CONSTRUCTION PLANS FOR:

**OWL MARKETPLACE**  
 EL PASO COUNTY, COLORADO

**GENERAL NOTES & ROAD CROSS SECTIONS**

**Know what's below. Call before you dig.**  
 CALL 2-BUSINESS DAYS IN ADVANCE BEFORE YOU DIG, GRADE, OR EXCAVATE FOR THE MARKING OF UNDERGROUND MEMBER UTILITIES.  
 PCD FILE: VR2321

**SIGNAGE & STRIPING PLAN**

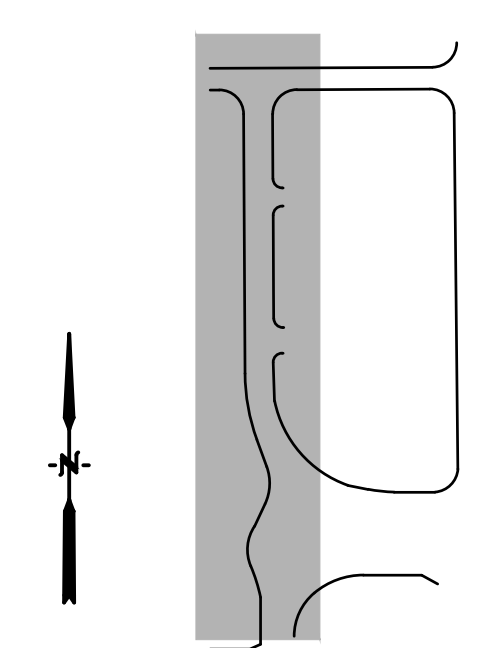
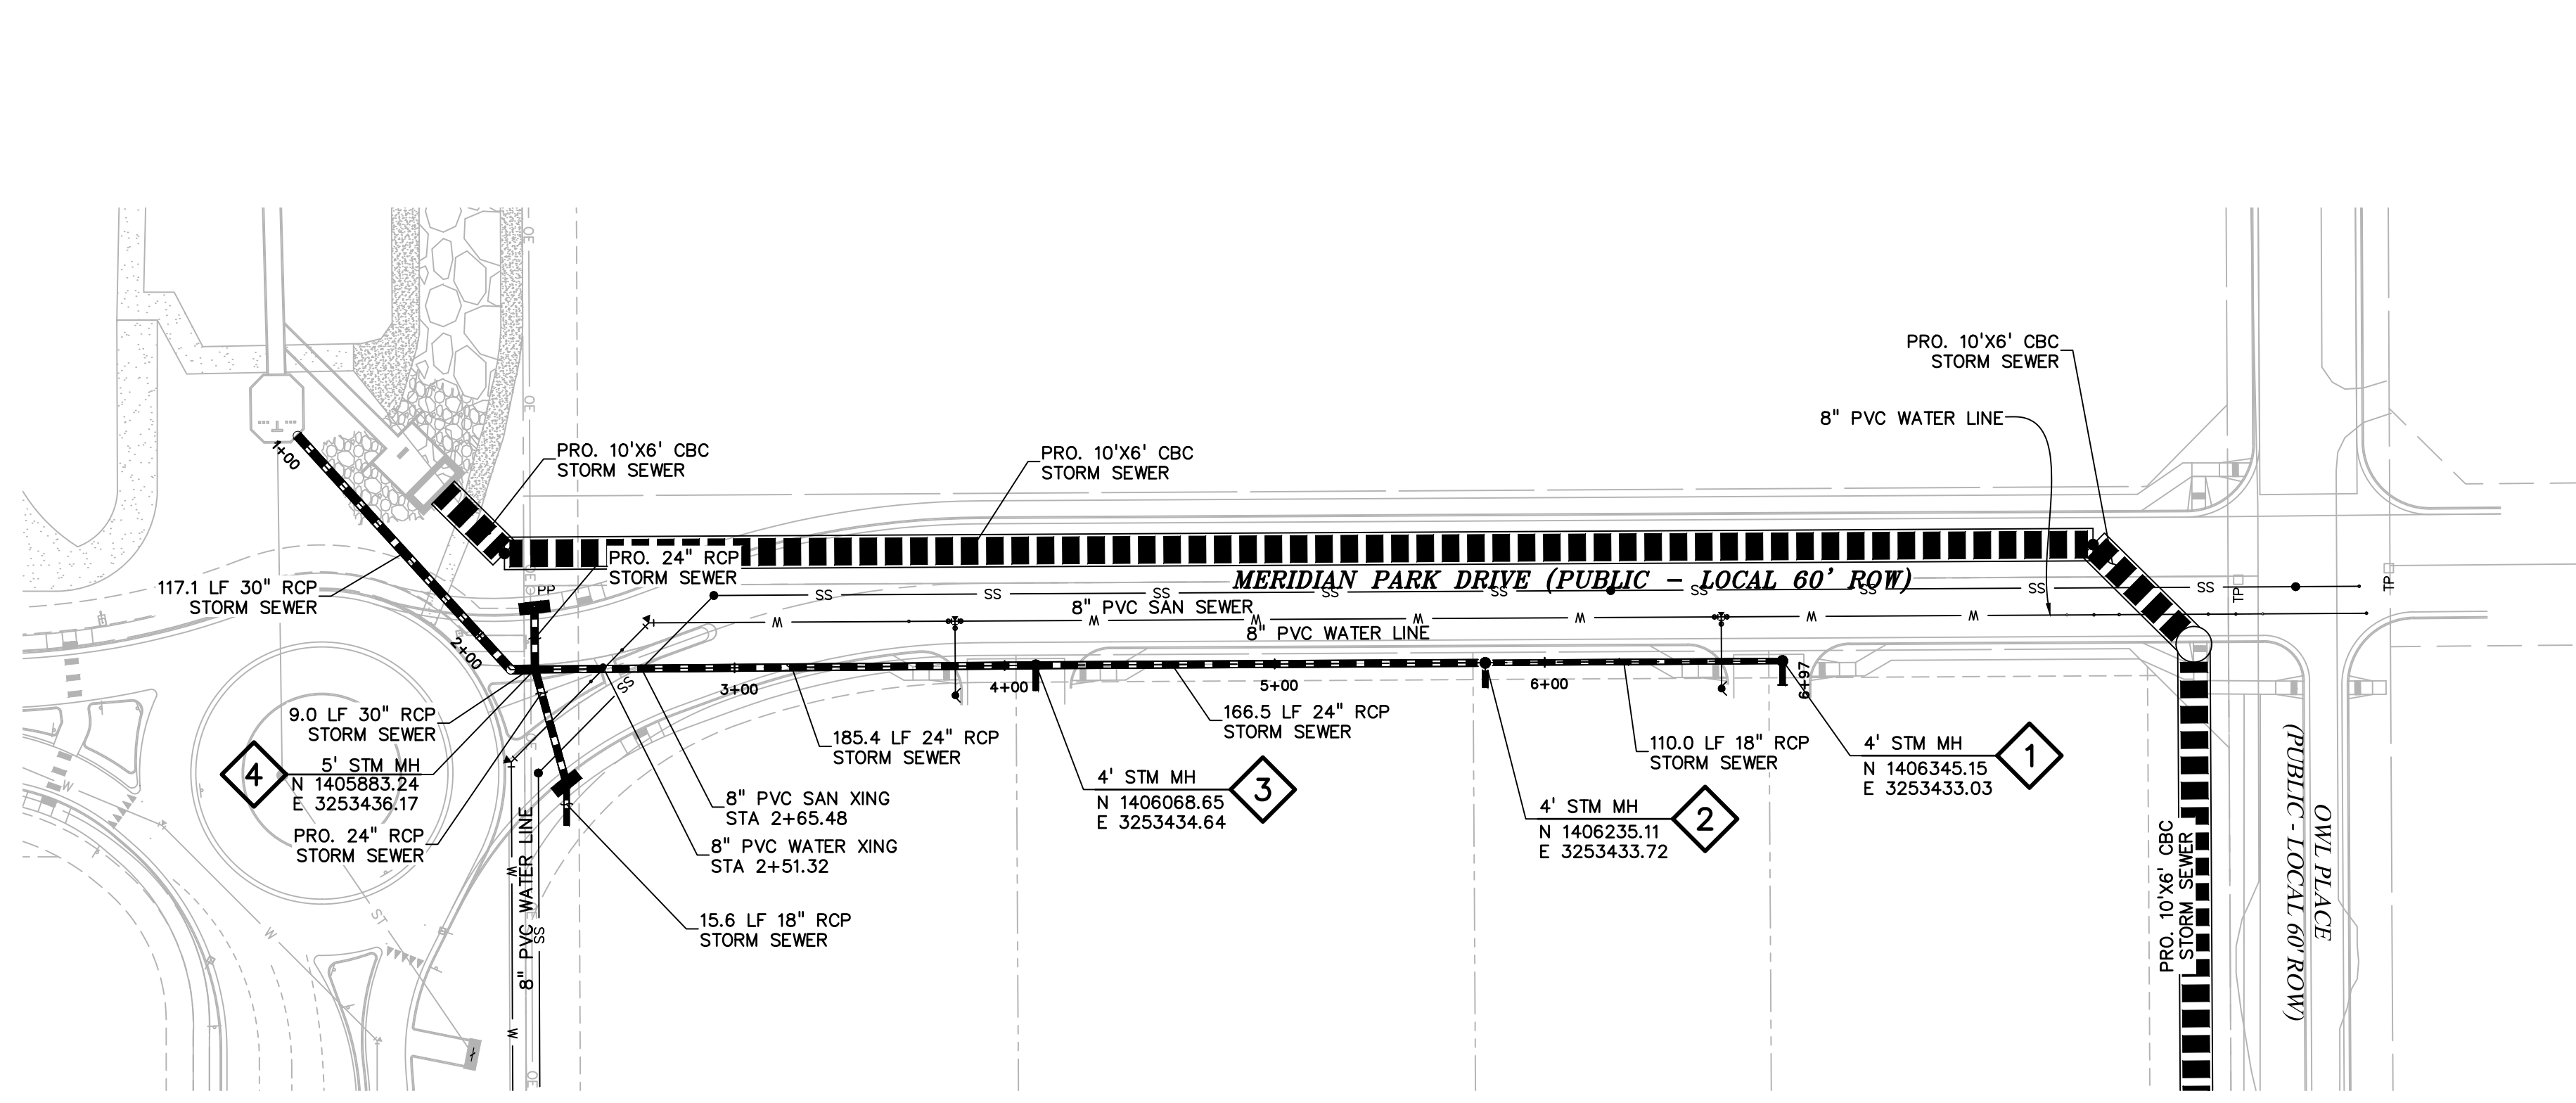
include R1-6 crosswalk sign and D1-1d street name sign as done on the existing roundabout

**STORM SEWER PLAN & PROFILE EAST MPD**

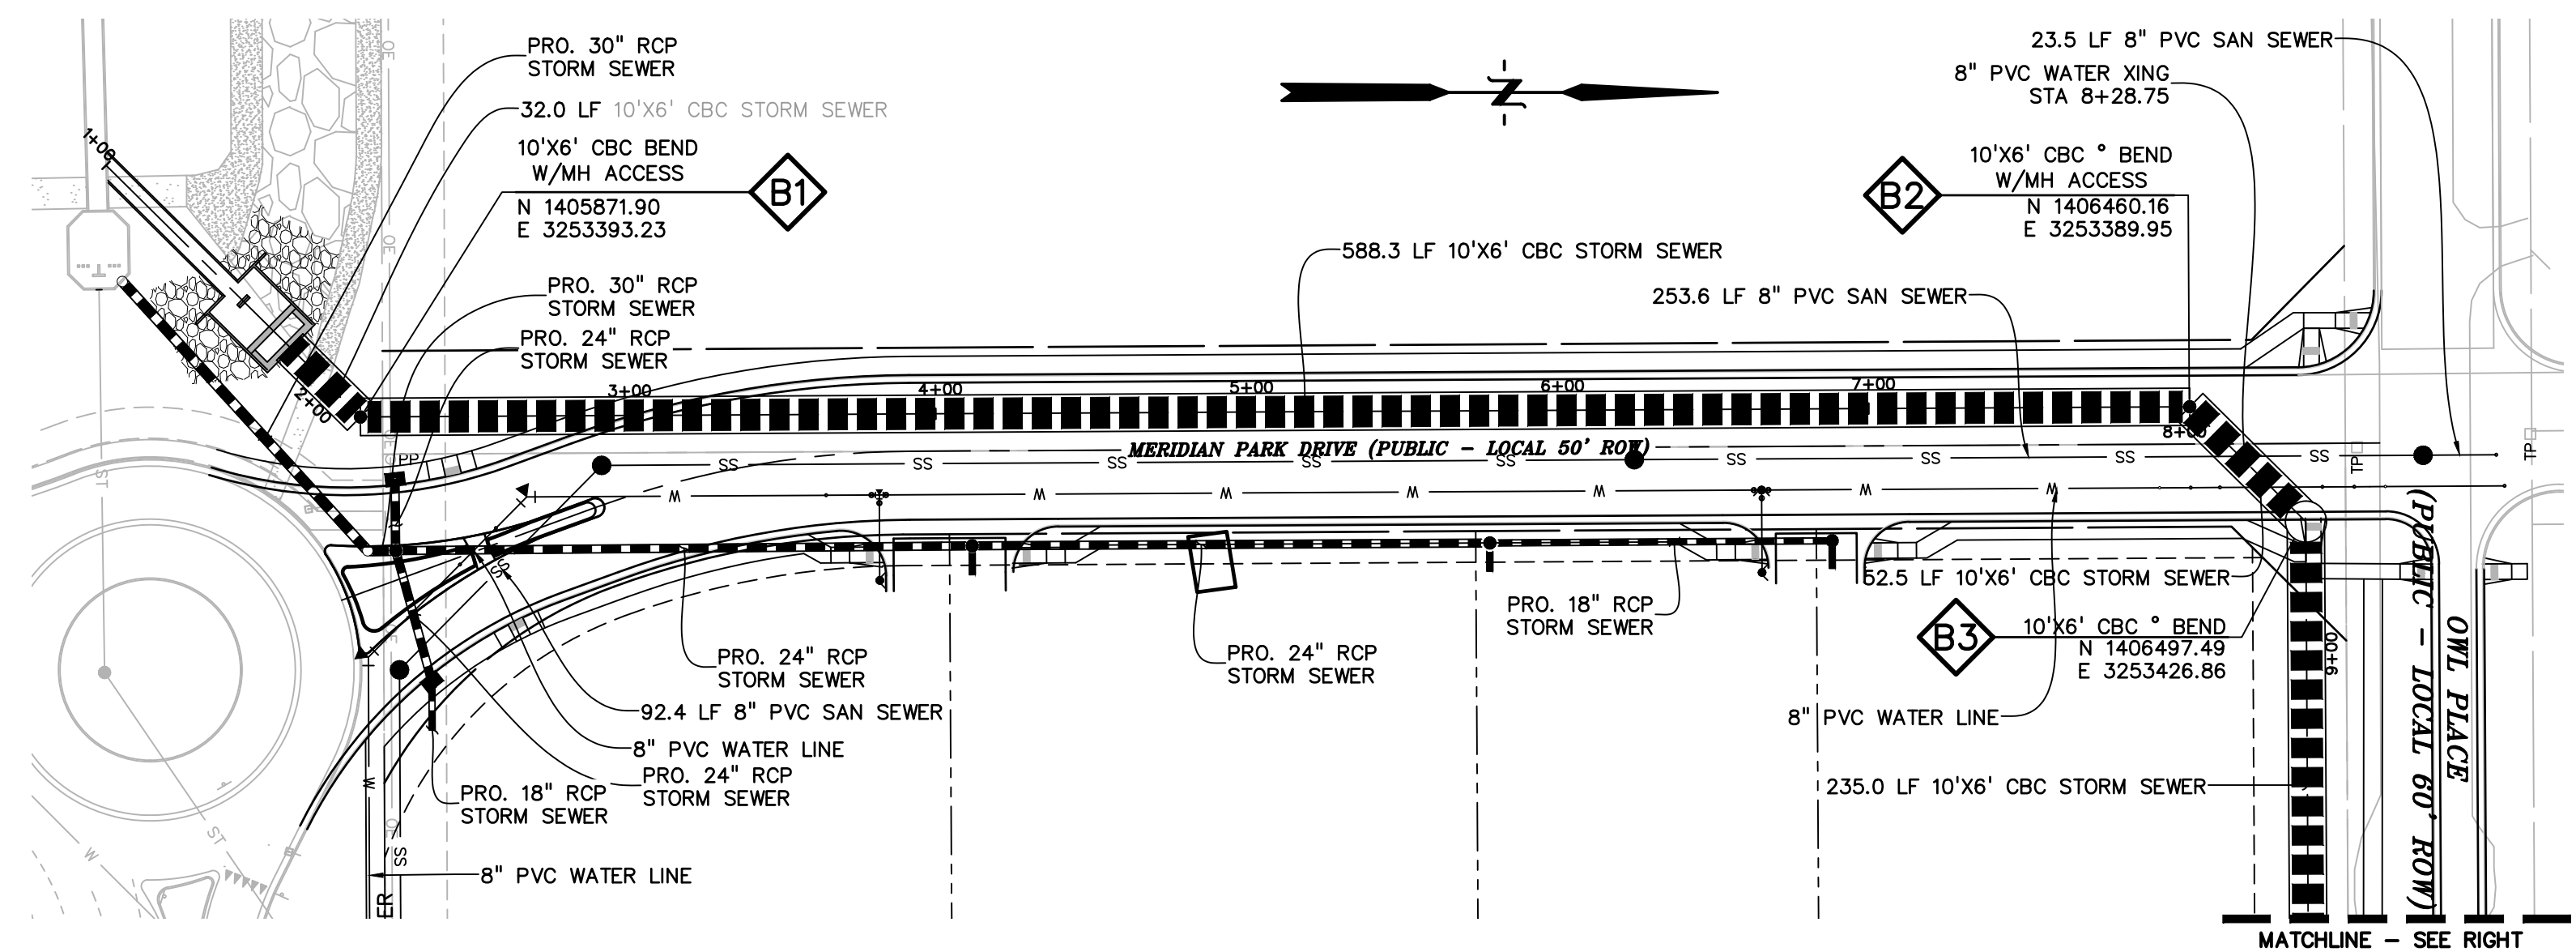
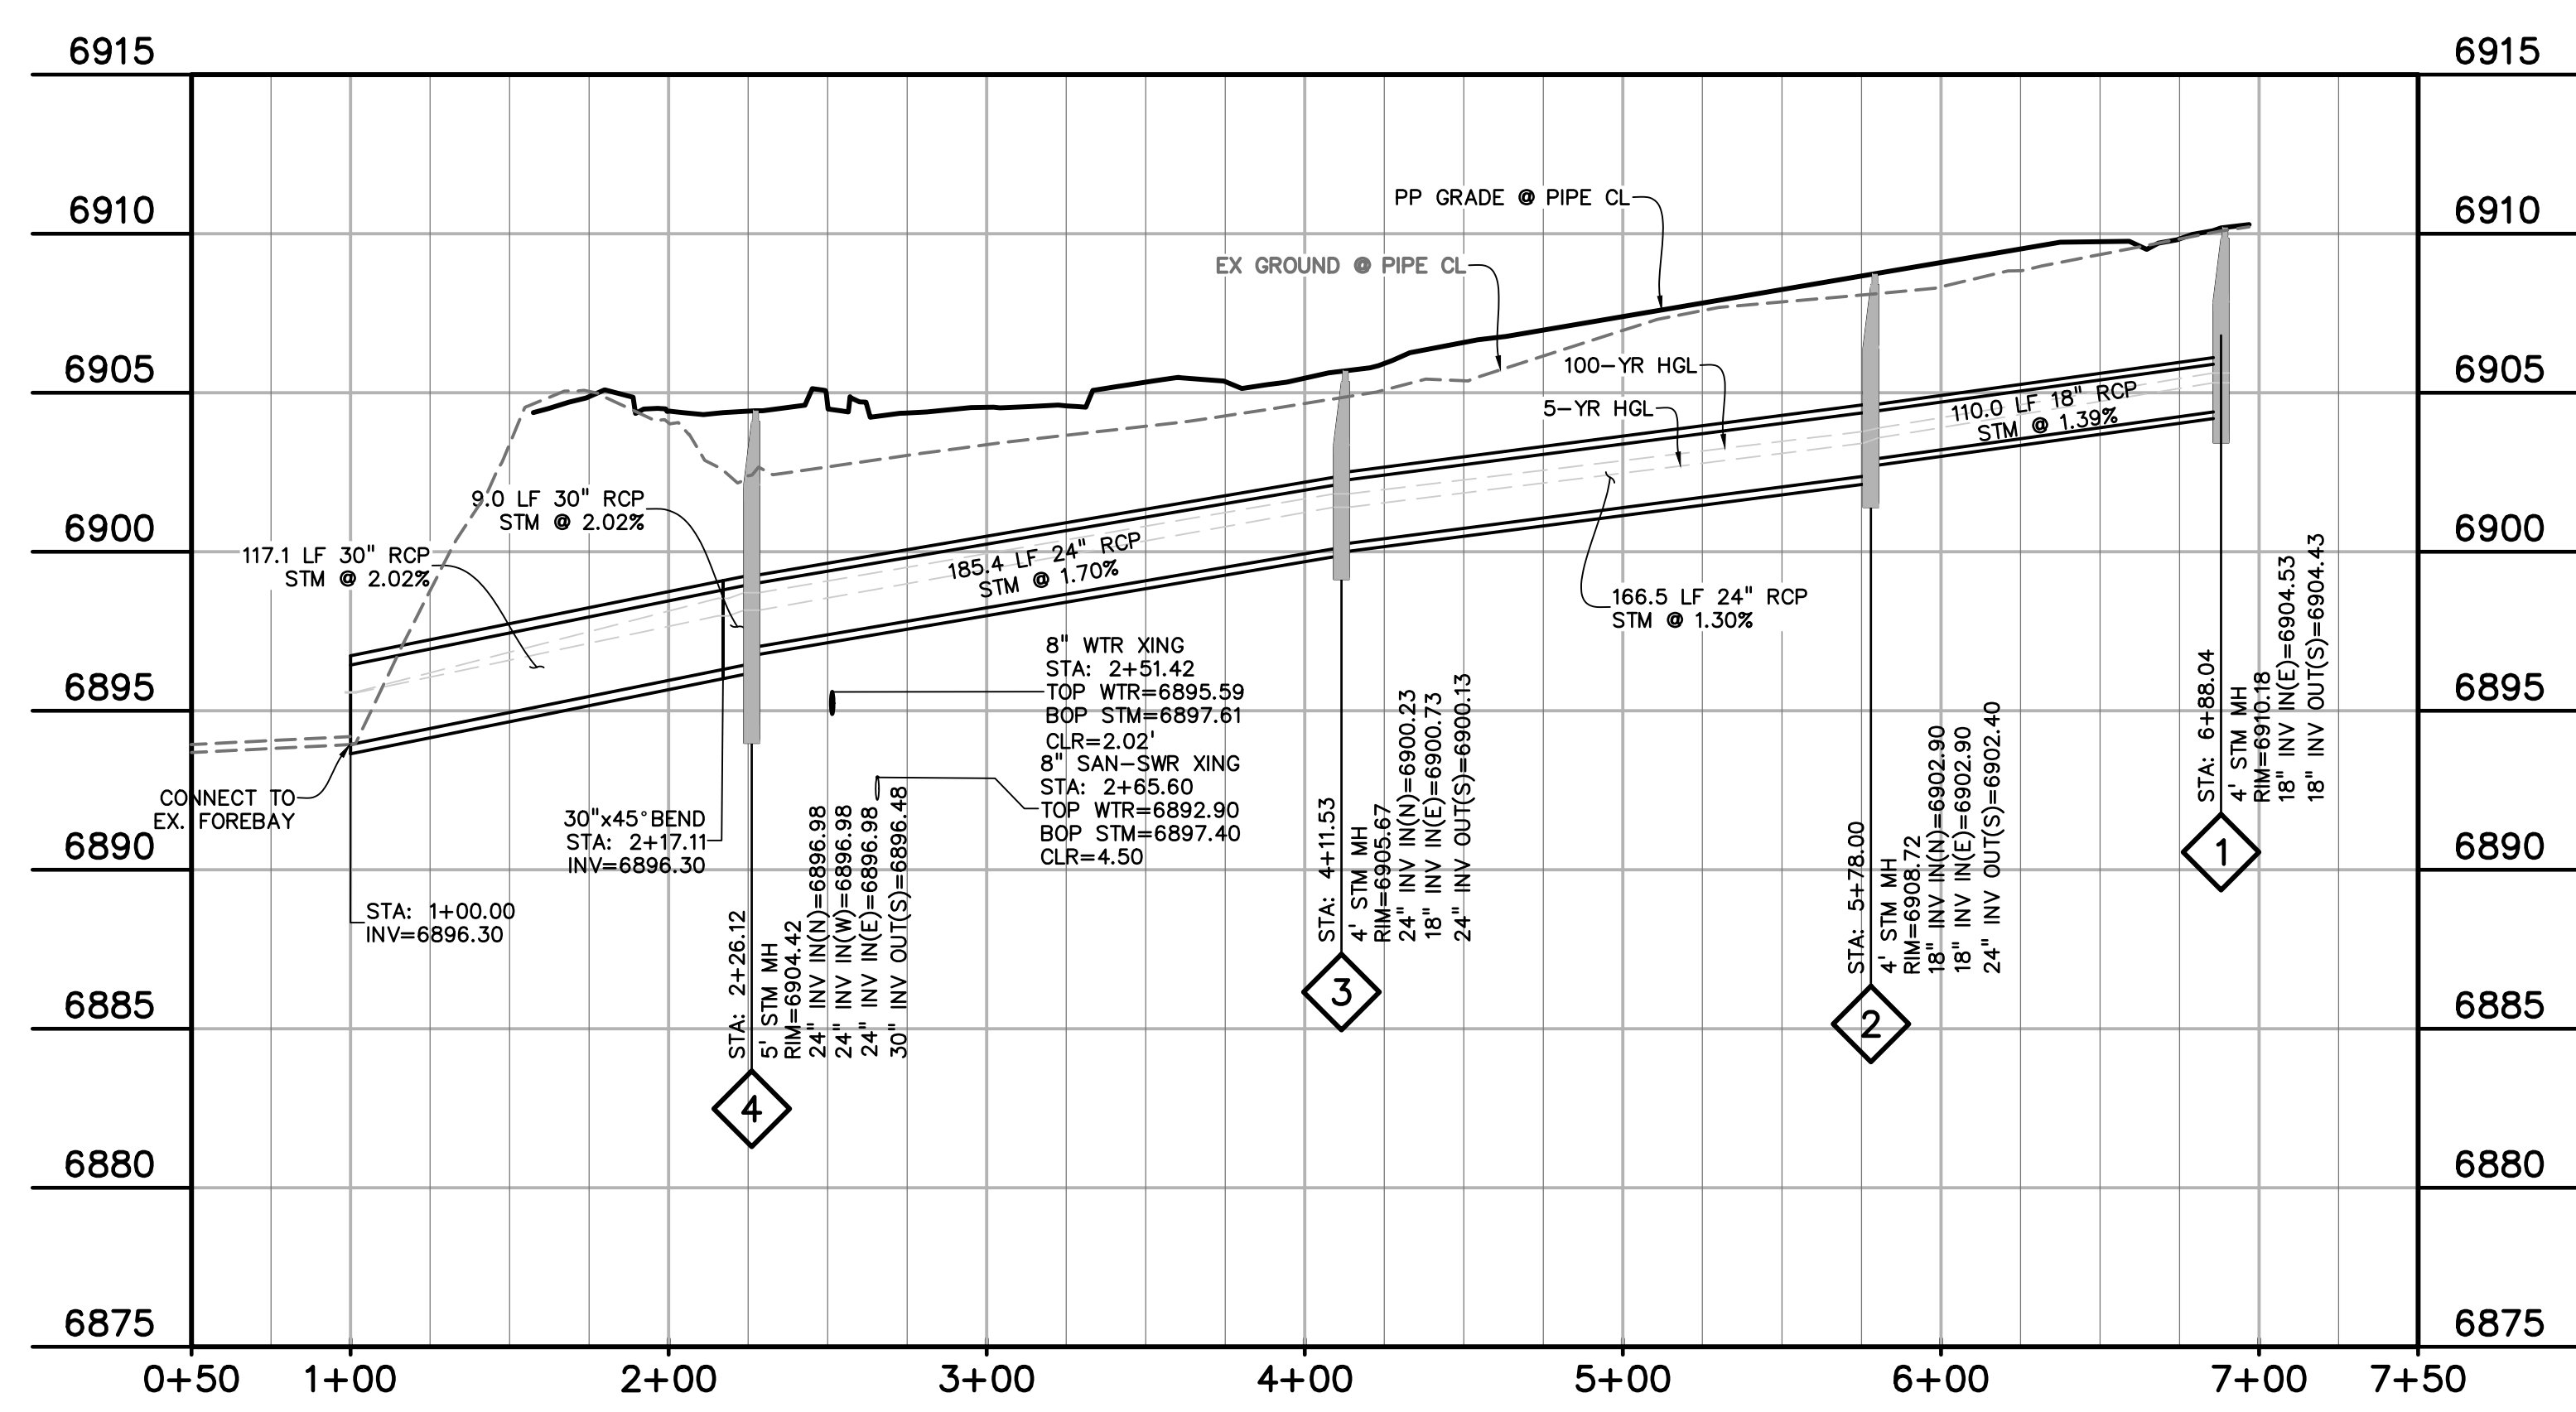
review 1: Label property and show easements  
 review 2: Unresolved
